P.O.A.D.P. PLAN

O'CONNOR 172

Re: O'Connor 172

POADP # 553

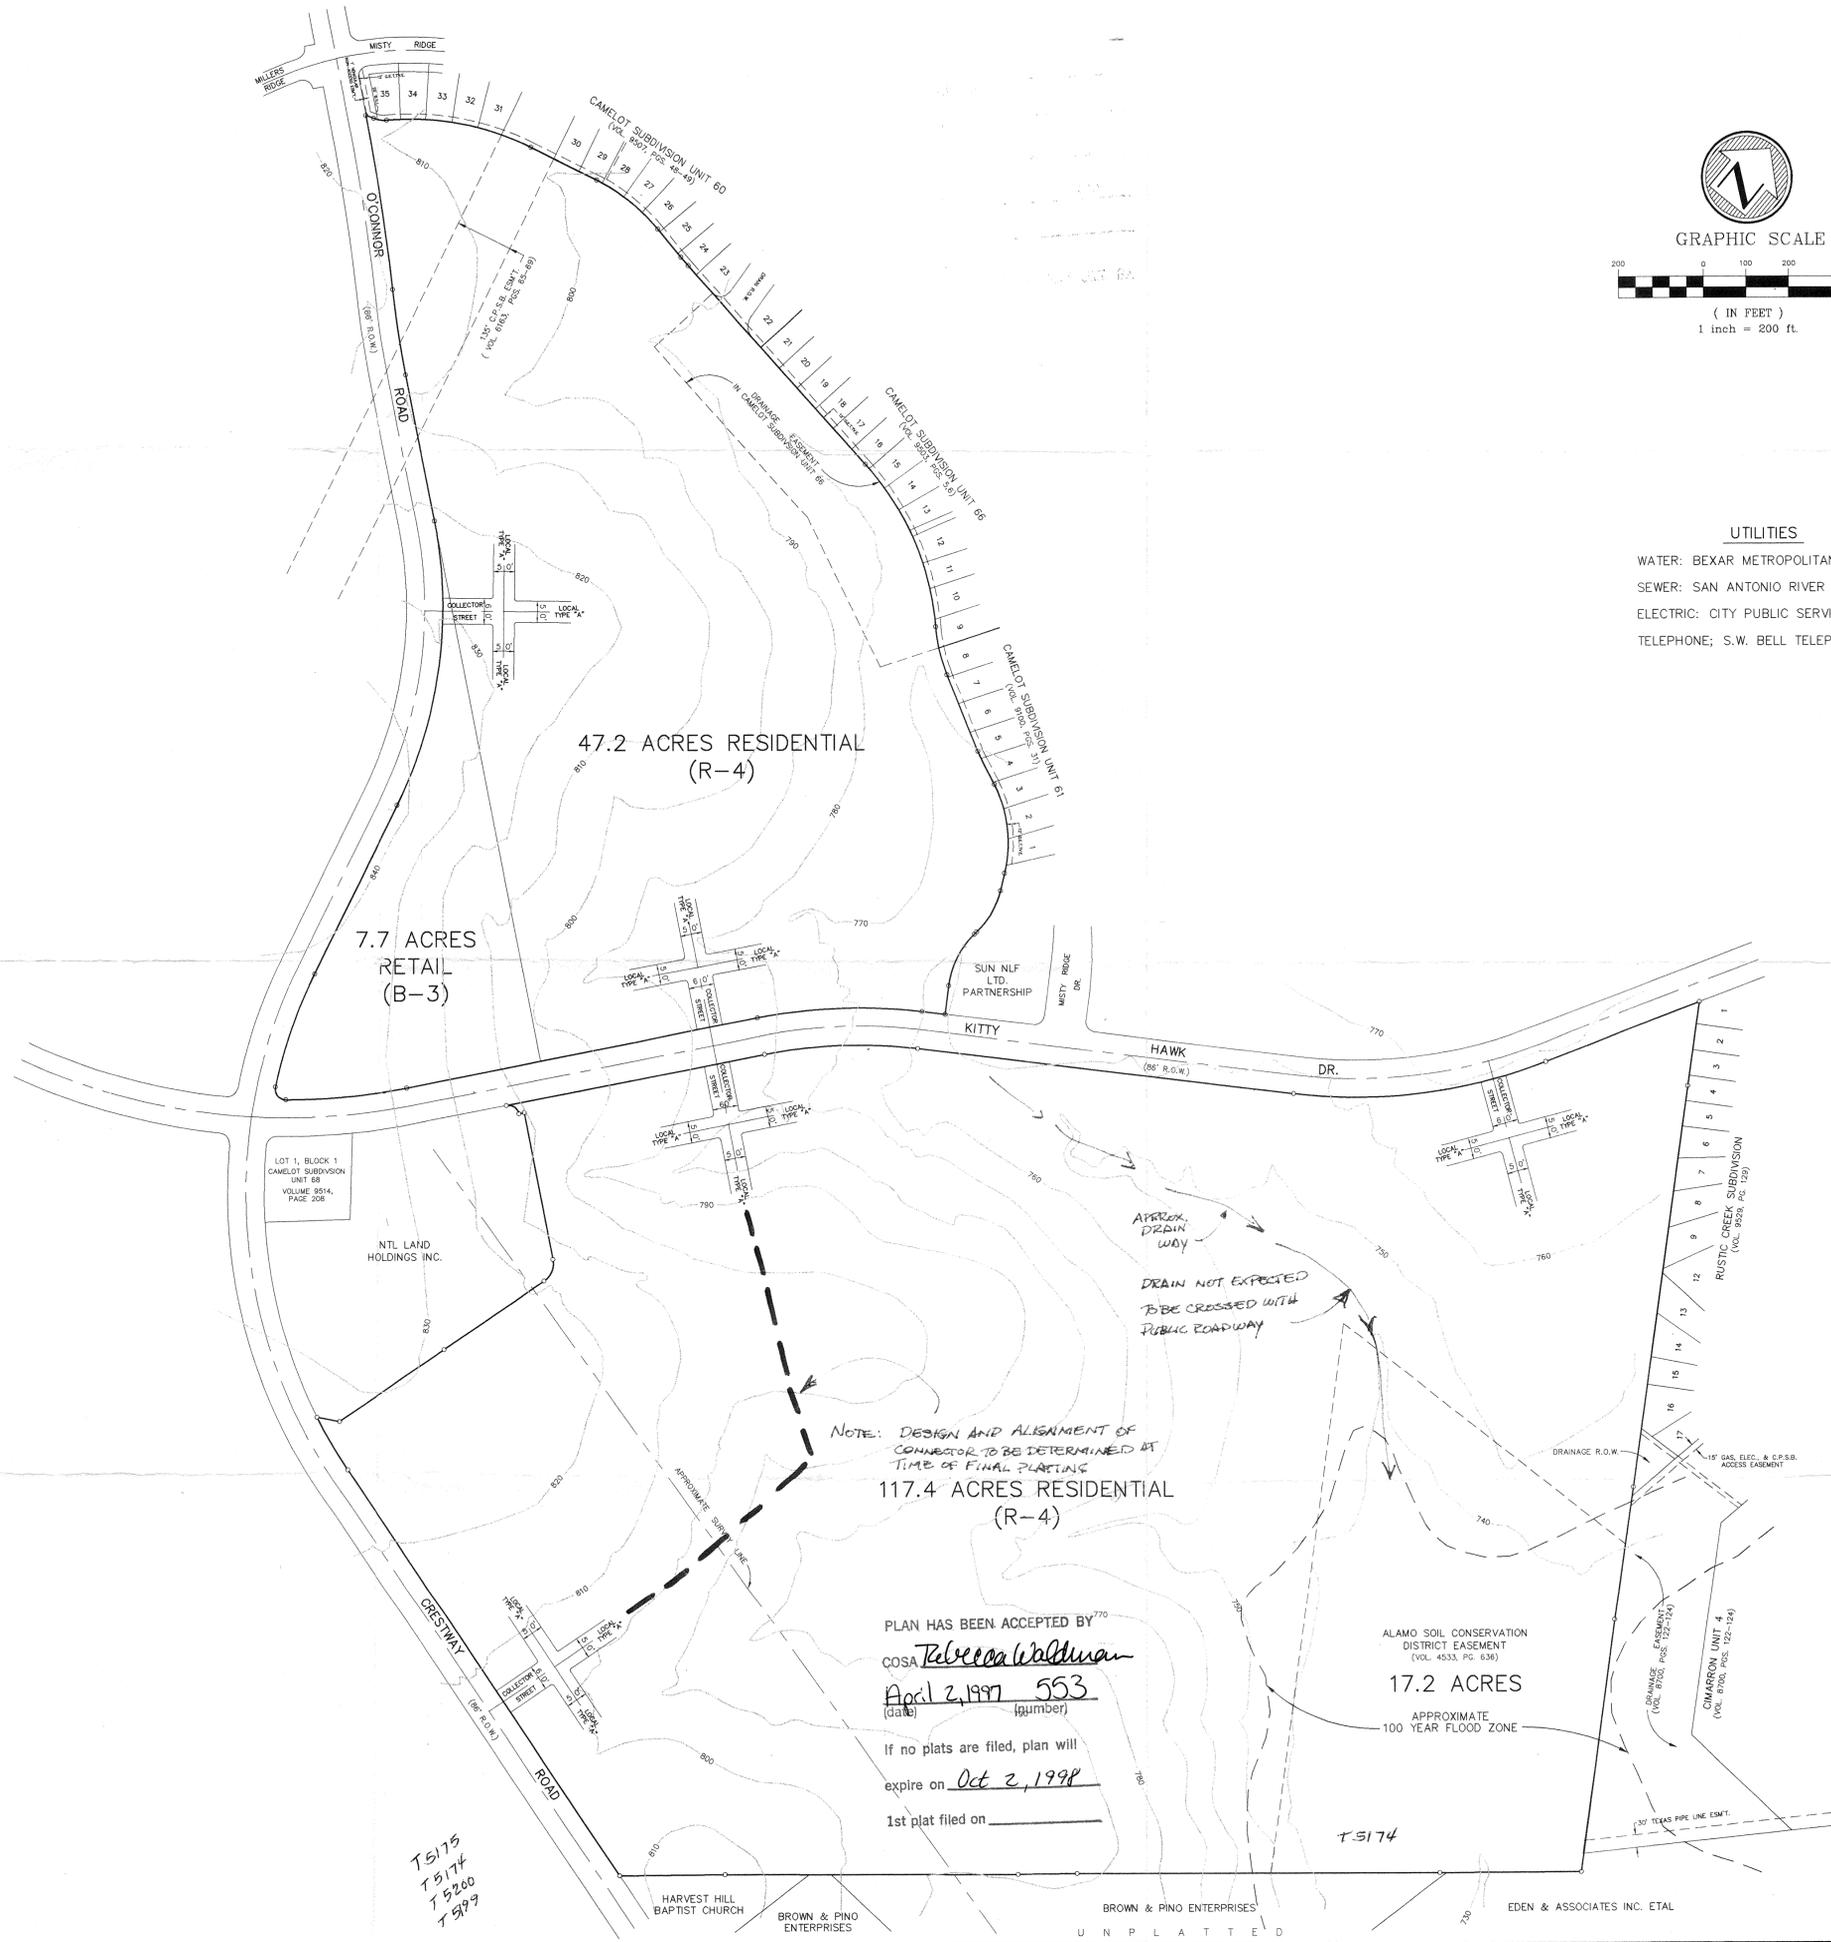
The City Staff Development Review Committee has reviewed O'Connor 172 Subdivision Preliminary Overall Area Development Plan # 553. Please find enclosed a signed copy for your files. Although your plan was accepted, please note the following:

- Based on the topography, a Flood Plain Study and drainage review will probably be required during the platting process.

It is my understanding that City Staff has stated that referenced POADP does not comply with the code requirements for a POADP - specifically Section 35-2075(e) with respect to the circulation system. It is my opinion that the plan - as submitted - does comply. However, in an effort to satisfy staff, I have revised the plan and am resubmitting same. The revised plan shows *more detail* of the traffic circulation system at the entrance into the various subdivisions. The revised plan indicates that the collector street will split into three(3) local Type 'A' streets at the first intersection into the subdivision. The fact that the proposed collector streets shown were not going to provide thru access was clearly stated in the TIA that was submitted to and reviewed by the Traffic Department.
